Agenda Item 2a
Bank Storage Withdrawal &
Aquifer Storage and
Recovery
Water Appropriation
Applications

Bank Storage Withdrawal Well Applications 45569 through 45575

The applications were filed for bank storage wells for the City of Wichita's Aquifer Storage and Recovery system. The applicant proposes to pump water temporarily stored in the banks and bed of the Little Arkansas River during above-baseflow stage, and recharge it into the Equus Beds aquifer.

Figure 4. –
 Application
 No. 45569
 Lithologic Log
 and Construction
 Design for
 Bank Storage
 Well

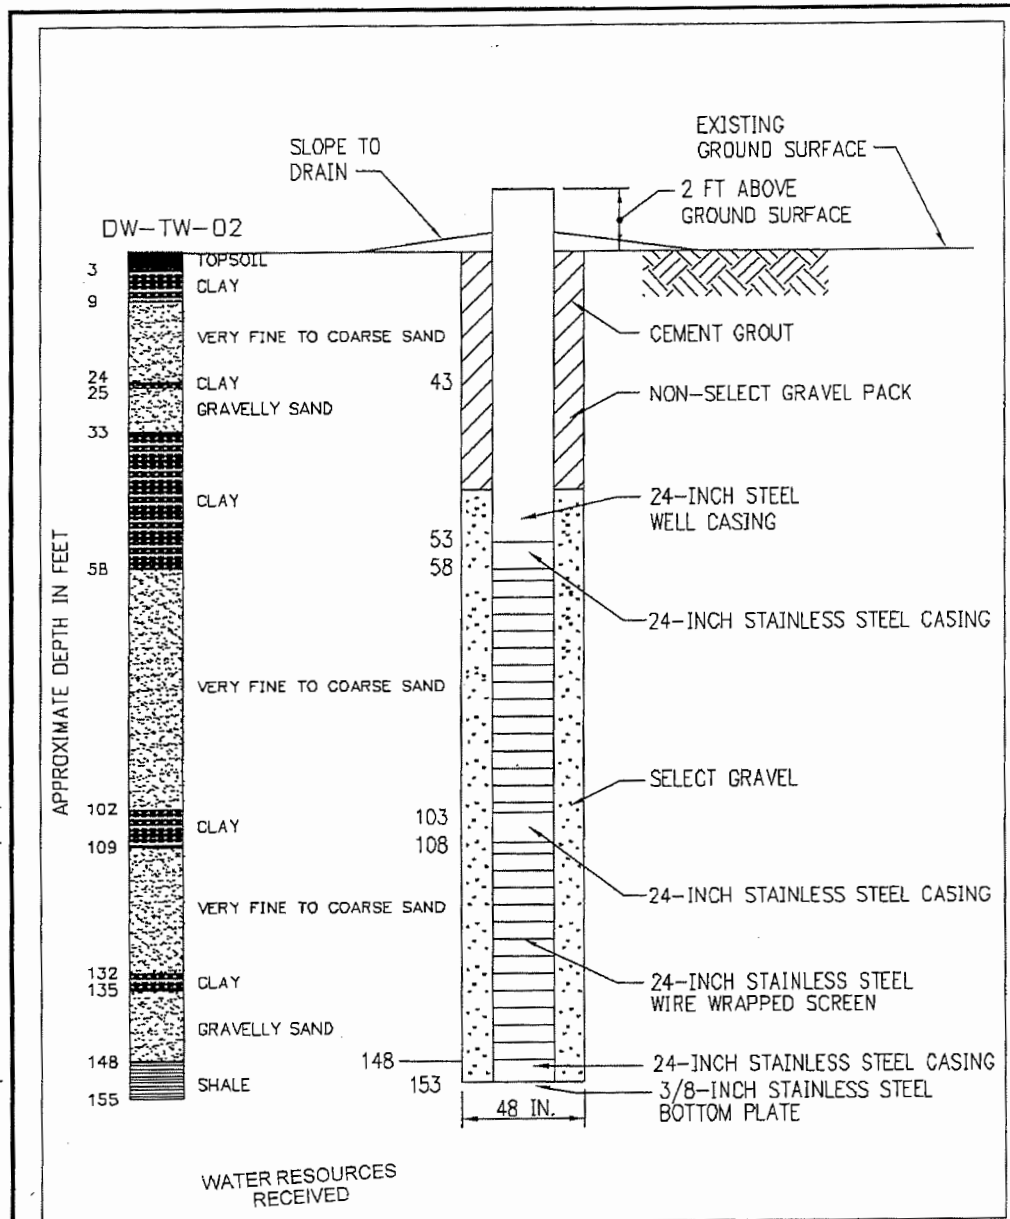
KS DEPT OF AGRICULTURE
 NOTE: FINAL DESIGN TO BE BASED
 ON PILOT HOLE FOR
 DIVERSION WELL.

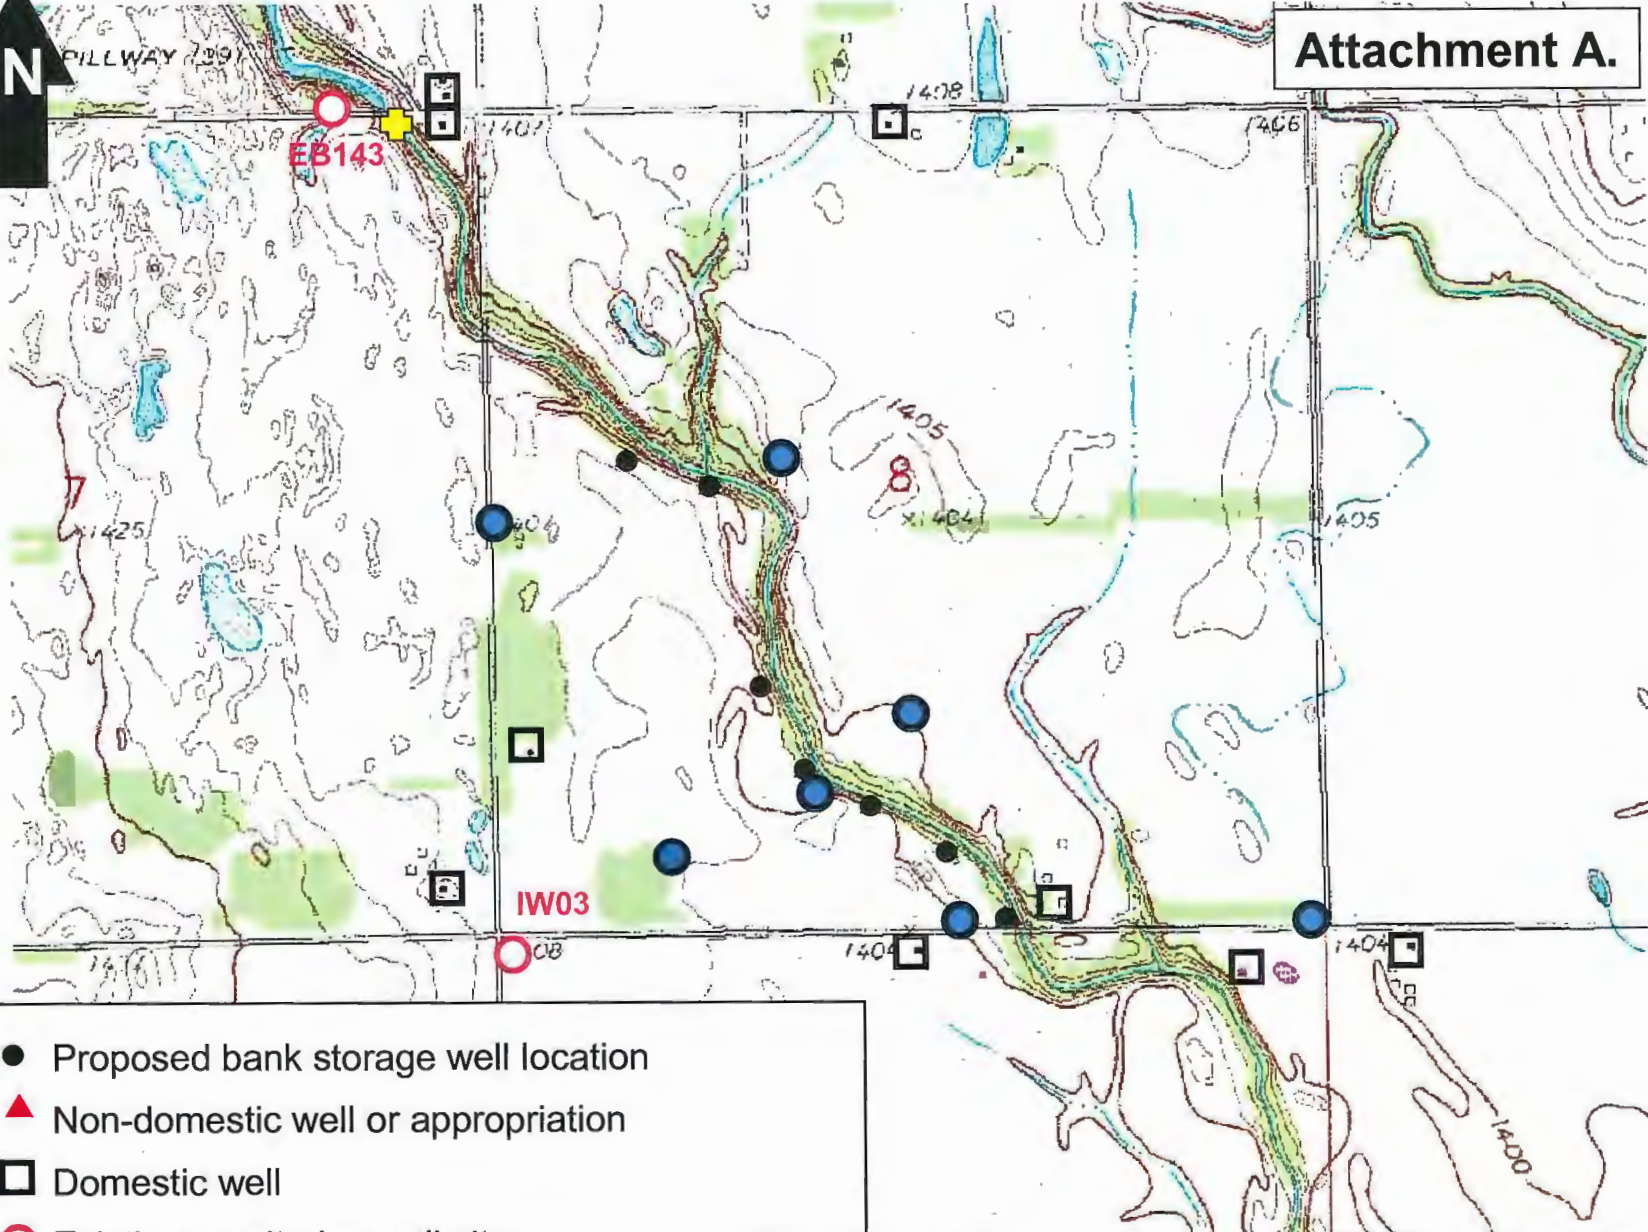
- 7. streamflow data utilized to determine flow conditions and bank storage well utilization shall be collected from the USGS Halstead gage site located at Highway 50, and from an upstream gage site to be established under the same parameters as the Halstead gage site;**
- 8. the upstream streamflow gaging station shall be installed between one-half mile and one mile of the northernmost bank storage well (identified as DW-7);**

Attachment A. – Application No. 45570 Site Map - NW 08-23S-2W
Prepared by: Equus Beds Groundwater Management District No. 2 - 07/06/04

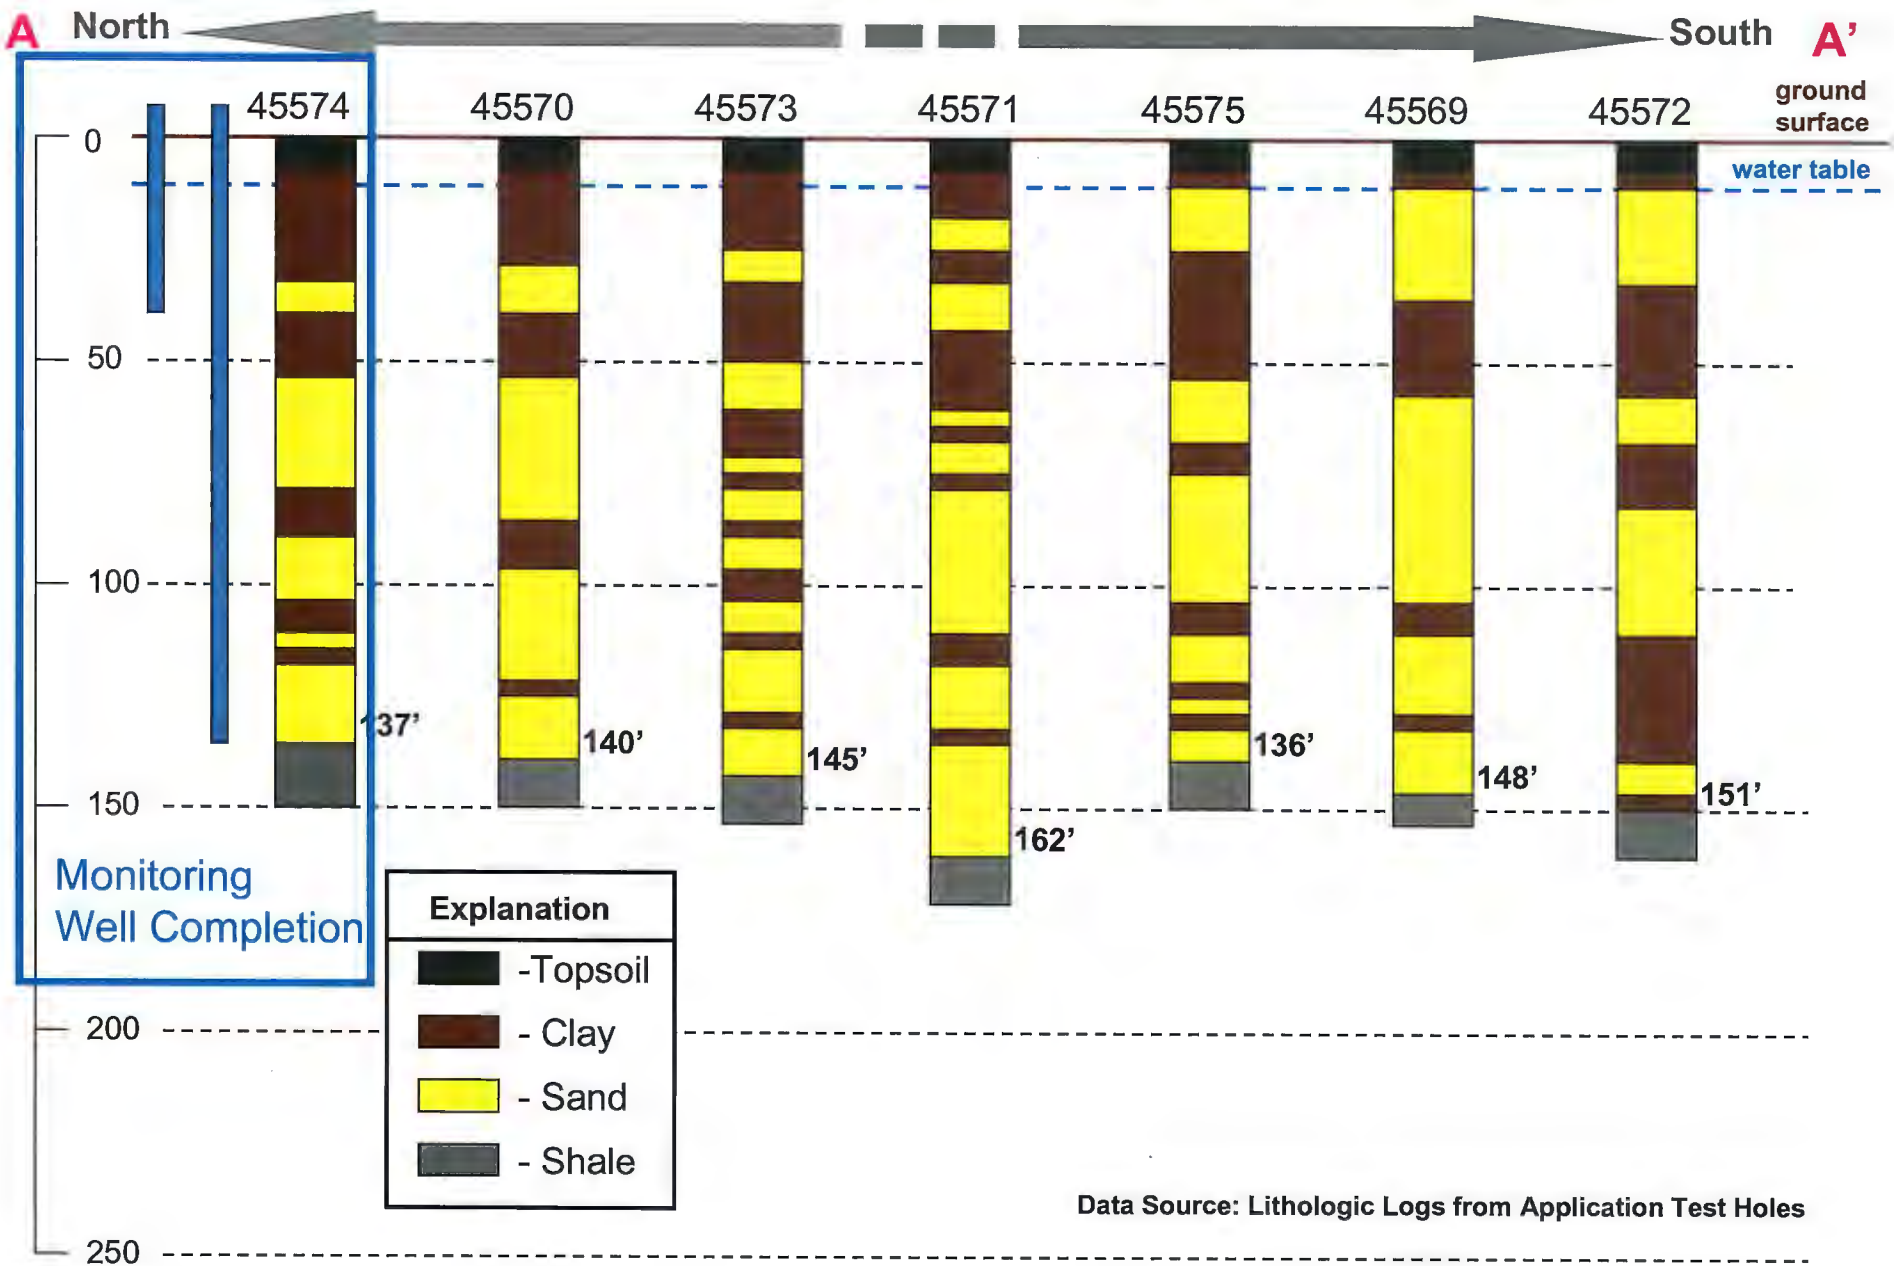
- 9. a monitoring well network is completed at the bank storage pump site as shown on Attachment A, and shall include existing monitoring well sites IW03, EB143 and EB144;**
